ENCLOSURE
RESPONSE TO REQUEST REGARDING THE REVEITEMENT
DITCH SYSTEM.....

Re: Nine Mile Point Unit 2
Docket No. 50-410

Enclosed is information requested in Mr. Vassallo's July 16, 1976 letter regarding the Revetment Ditch System for Nine Mile Point Unit 2. Five copies of this information are provided which respond to Questions 3 and 7.

FIGURE 1
LAKE ONTARIO -
MATHEMATICAL MODEL
BOUNDARIES AND GRIDS
30,000 FT. GRID SPACING

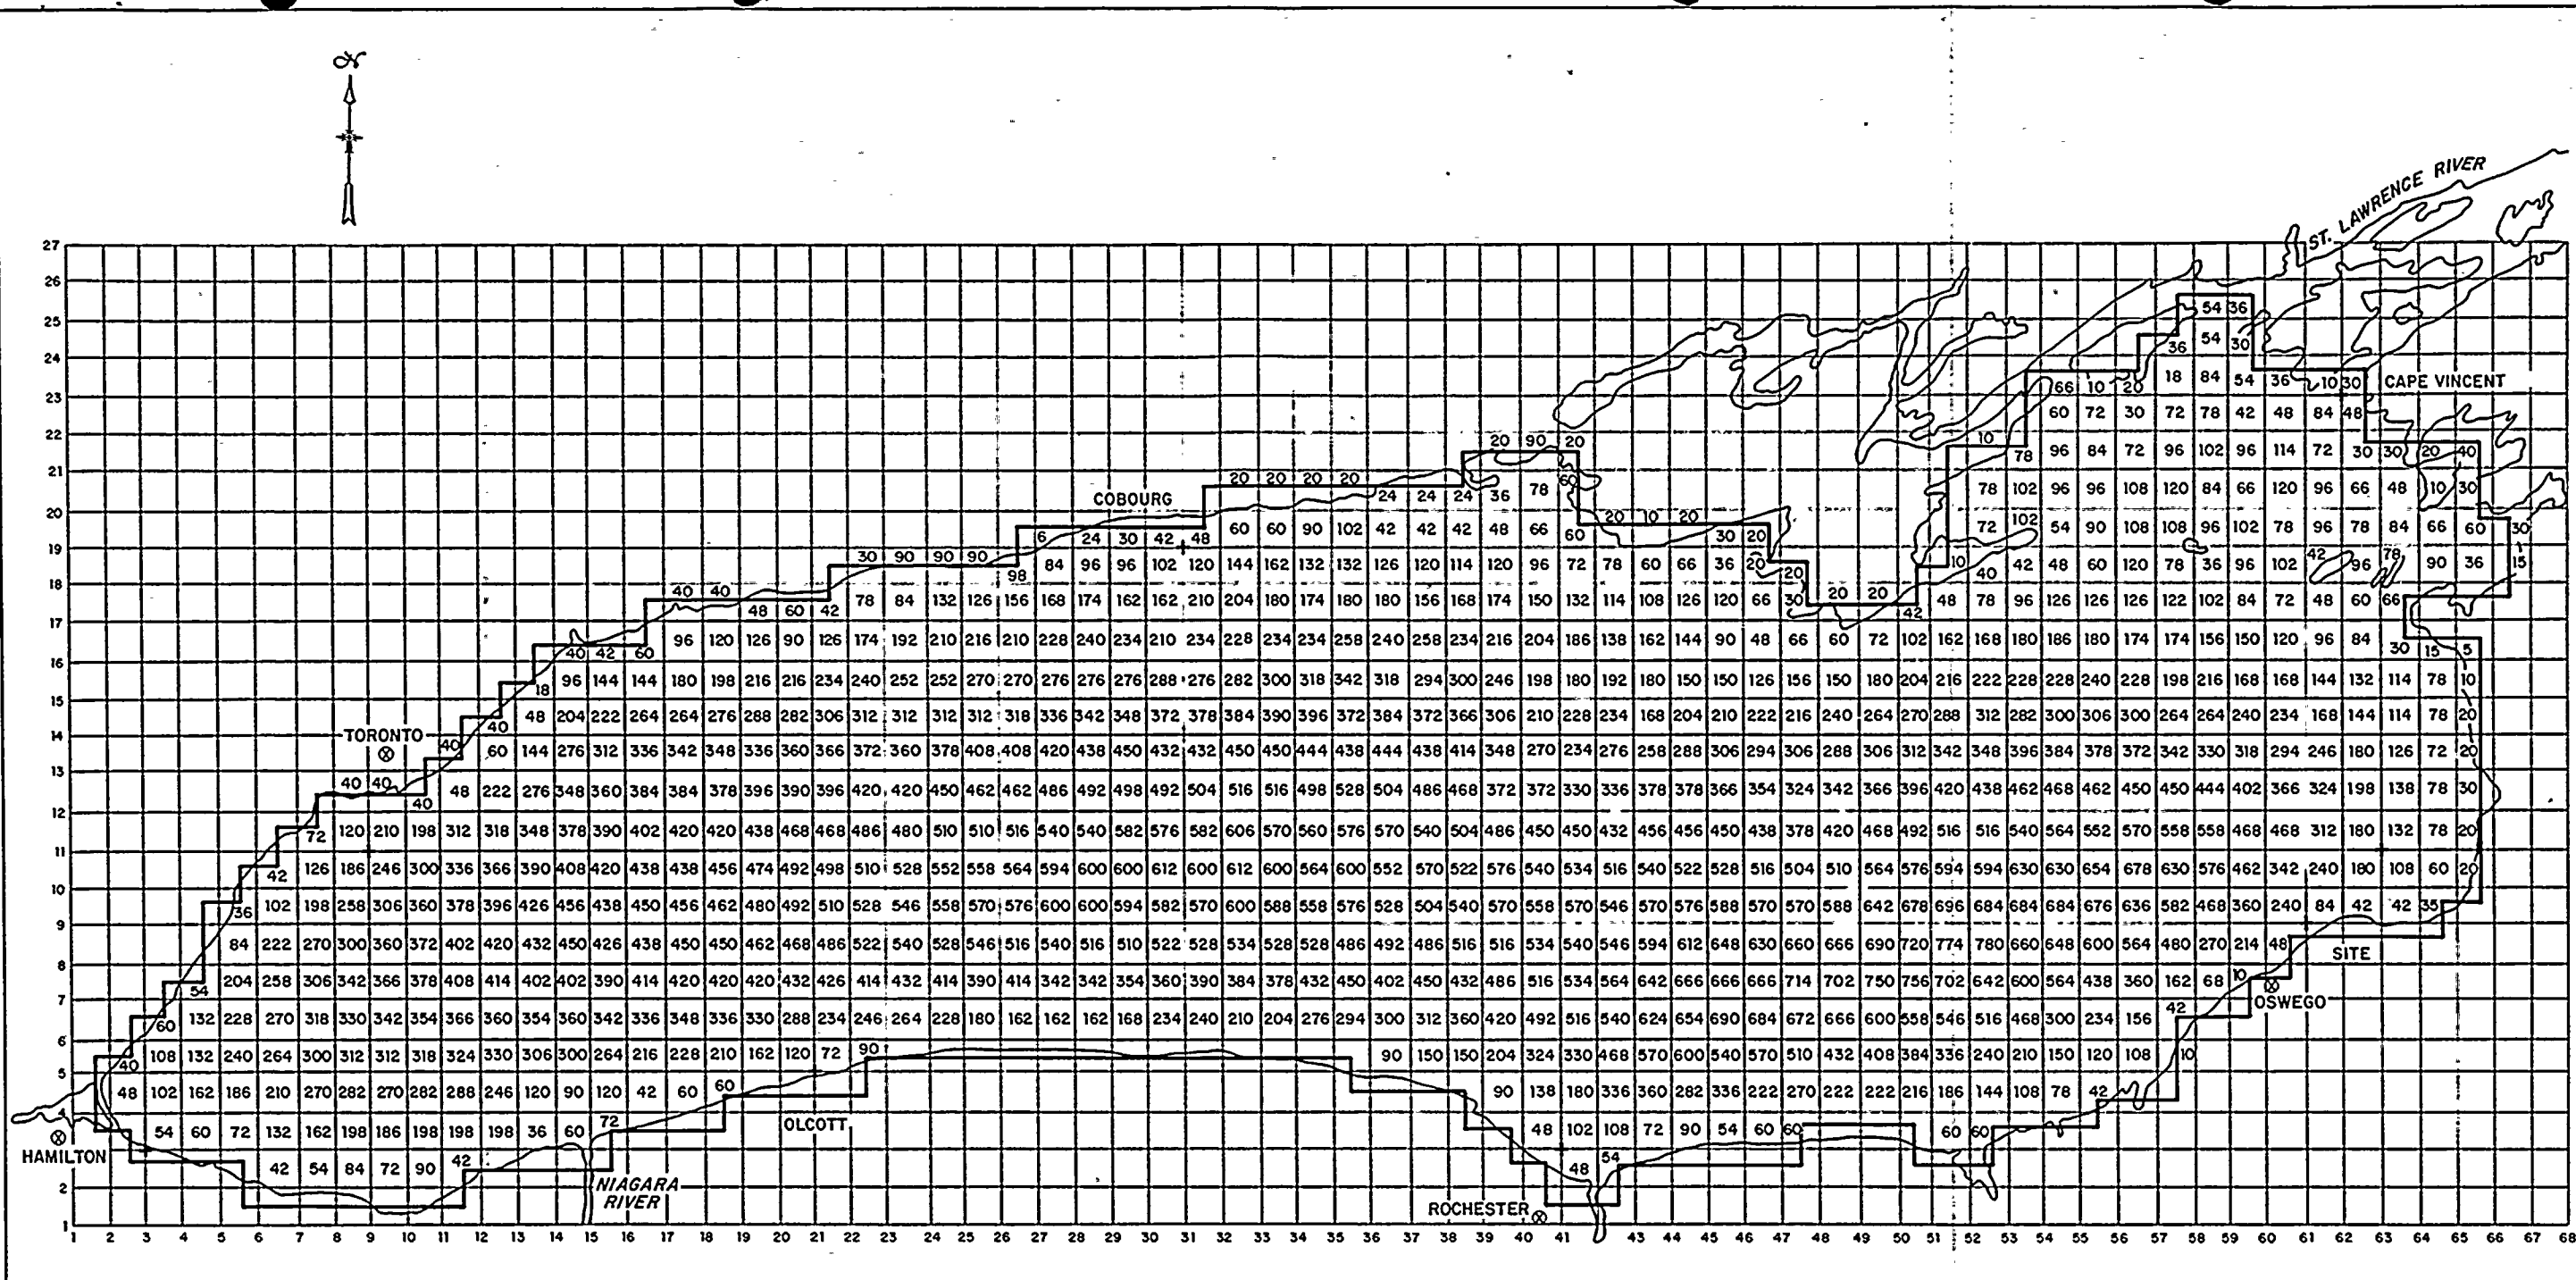
The grid spacing used in the analysis has not been shown to be adequately fine to produce conservative estimates of storm surge, particularly in the nearshore area. Verification studies revealed deficiencies in the model; these may be in part due to too coarse a grid. (Your referenced grid sensitivity analysis performed for a similar model used by Stone and Webster on Long Island Sound does not resolve the problem; the referenced review is incomplete.) No criteria for the choice of grid size has been presented by the applicant. It is our position that the grid size used in the model must be justified and shown to produce conservative results.

sizes are 2.8, 2.5, and 2.8 ft respectively. It should be noted that the grid point selected for the plant site with 30,000 foot and 15,000 foot grid size (Figures 1 and 2) is east of the grid point selected with 20,000 foot grid size. Since surge increases to the east end of the lake at the time of maximum surge, the increase in surge for larger and smaller grid sizes at the plant site is due to the location of the grid point used rather than the change of grid size.
